Appendix 2

#	Category of Information	Specific Request	Category 1 = pre- Clause 25 decision Category 2 = pre- hearing	Reasons for requested information
1	Māori Cultural Values (including associated geoh heritage and landscape values)	<p>(a) Please provide an assessment report from Ngāti Te Ata Waiohua which details the cultural impact of the plan change proposal on affected interests and values, including it's relationship to the land and waterbodies in and around Waitomokia.</p> <p>In conjunction with submitting the requested report, please also confirm any consequential amendments to the lodged plan change documents upon reviewing it's contents, including assessment of the plan change proposal to demonstrate accordance with relevant NZCPS and RPS provisions, noting the relevance of specific provisions listed and described in associated further information item (1)(b) below.</p>	1	<p>Appendix 2B to the plan change application contains a high-level overview document on the plan change proposal from Ngāti Te Ata Waiohua which states that it does not support the proposal in its current form and will provide a more detailed cultural impact assessment (CIA) report in the near future.</

Figure 9: Indicative high-level masterplan used in consultation, note the public pathway access to the paa shown on the plan is not supported by Mana Whenua and will not be incorporated.

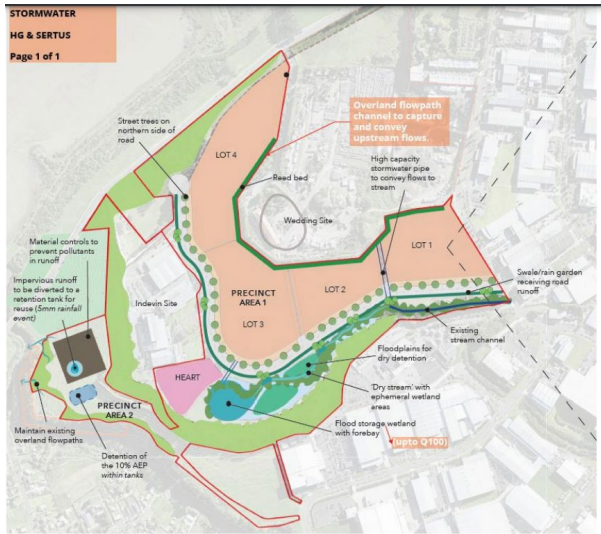
It is also recommended that any visual modelling of future development within the proposed precinct should remove the existing pines near Oruarangi Creek, as they are aging and seem incompatible with the revegetation and 'naturalising' of the creek margins and lower tuff slopes suggested in the lodged landscape and visual effects assessment (Figures 9 and 10 below).

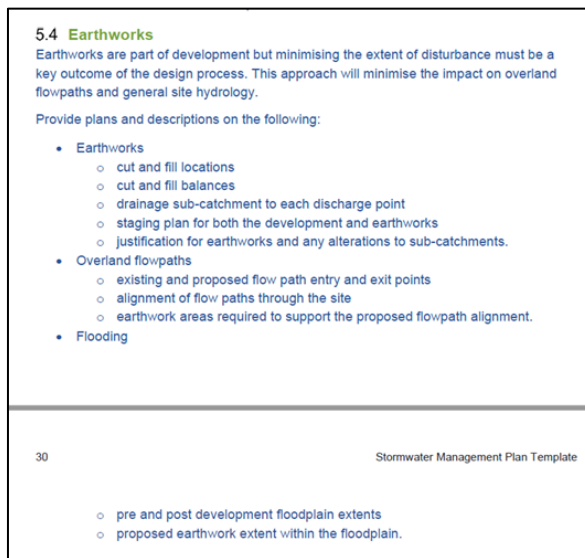
Please clarify whether the Montgomerie outlet will be replaced by an open channel as per the plan below, or whether it is planned to upgrade the existing 1200mm dia culvert and also clarify how the peak 1% AEP flow rate of 8.53m³/s will be conveyed to the open channel downstream
